Project	<b>IEEE 802.16 Broadband Wireless Access Working Group</b> < <a href="http://ieee802.org/16">http://ieee802.org/16</a> >	
Title	<b>Comments on Mobility Modeling in Draft IEEE 802.16m Evaluation Methodology Document (Section 9.1)</b>	
Date	<b>2007-04-30</b>	
Source(s)	Rob Nikides	Robert.Nikides@motorola.com
	Fan Wang	fanw@motorola.com
	Motorola	
Re:	Call for Comments and Contributions on Project 802.16m Evaluation Methodology, 2007-04-09	
Abstract	This document highlights several areas where the Evaluation methodology is not adequately defined for mobility analysis, proposes modifications for some and suggested course of action for mobility environment definition.	
Purpose	Propose changes to mobility movement and RF environment modeling in Section 9.1.	
Notice	This document has been prepared to assist IEEE 802.16. It is offered as a basis for discussion and is not binding on the contributing individual(s) or organization(s). The material in this document is subject to change in form and content after further study. The contributor(s) reserve(s) the right to add, amend or withdraw material contained herein.

# Comments on Mobility Modeling in Draft IEEE 802.16m Evaluation Met

**Figure 1.** - 7 cell abbreviated example of MS movement in a wrap around environment. Red lines denote paired wrap around boundary segment.

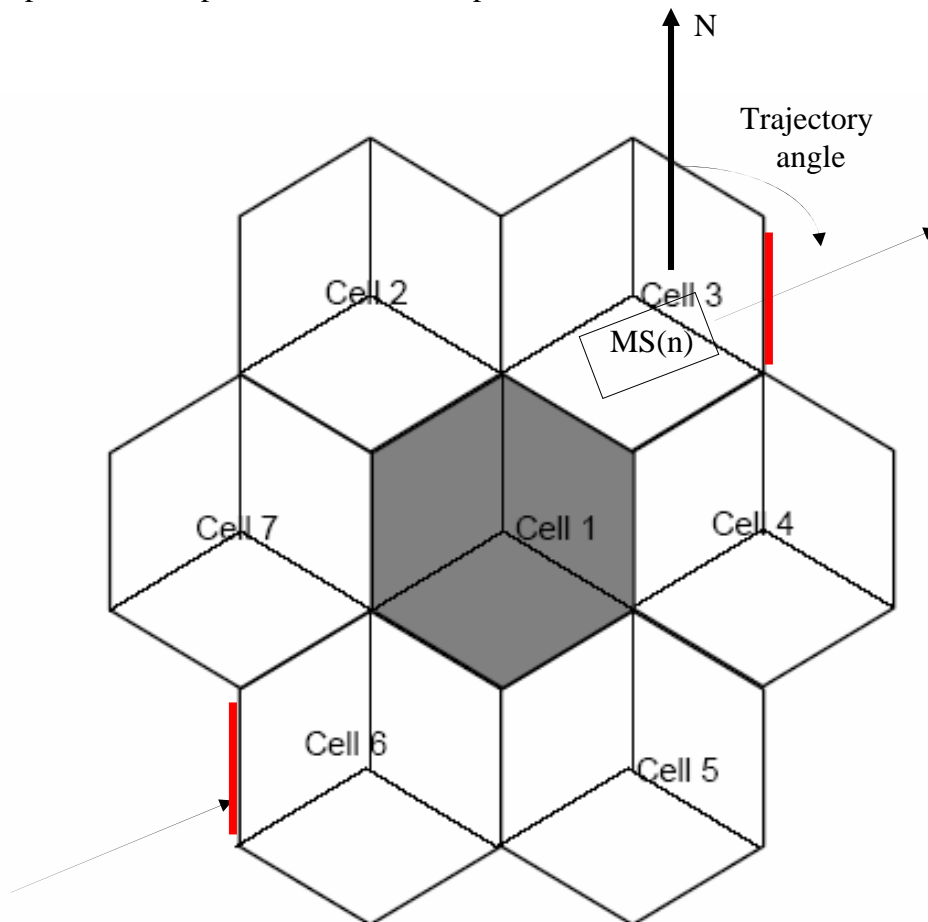
Movement of the MS is established by selecting a random speed for the users according to profiles in section 4.3.1 such that the population of MS users meets the desired percentages. The MS remains at the selected random speed and direction for the duration of the simulation drop. When a MS crosses a wrap around boundary point within the simulation space, the MS will wrap around to the associated segment identified within Appendix G, continuing to keep the same speed and trajectory. Figure 1 depicts an example of the movement process.

A TBD number of MSs are uniformly placed within the 19 cell, wrap around simulation space defined within Appendix G.

A dropped MS is assigned an angle of trajectory at the beginning of a call. The assigned angle is picked from a uniform distribution across the range of 0-359 degrees in one degree increments. The angle of zero degrees points directly North in the simulation environment.

**Figure 2** – Simplified representation of plane based approach to RF environment modeling

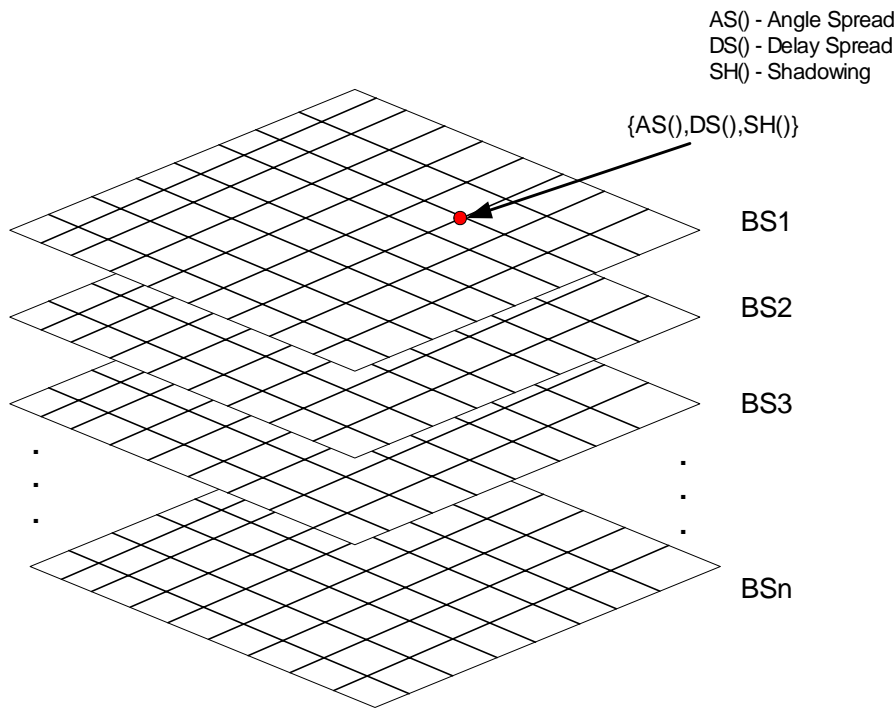
The second part of this proposal is to generate an RF model that reflects the transitional behavior of a real system, including de-correlation distance and the already modeled site to site correlations. One method to accomplish this is through a set of planes, with each plane representing the environment of a given site and/or sector over the simulation space. The planes are divided up in a uniformly spaced grid, using the de-correlation distance to define the desired spacing of sample points. Each point on the grid represents a triplet of angle spread, delay spread, and shadowing parameters. MS locations between the grid points are interpolated. The shadow values are then applied over the defined pathloss models. A visual representation of the model appears in figure 2.

In addition to the plane representation, a distance\_traveled\_for\_update parameter is also supplied to quantize the RF update interval (based upon distance traveled).
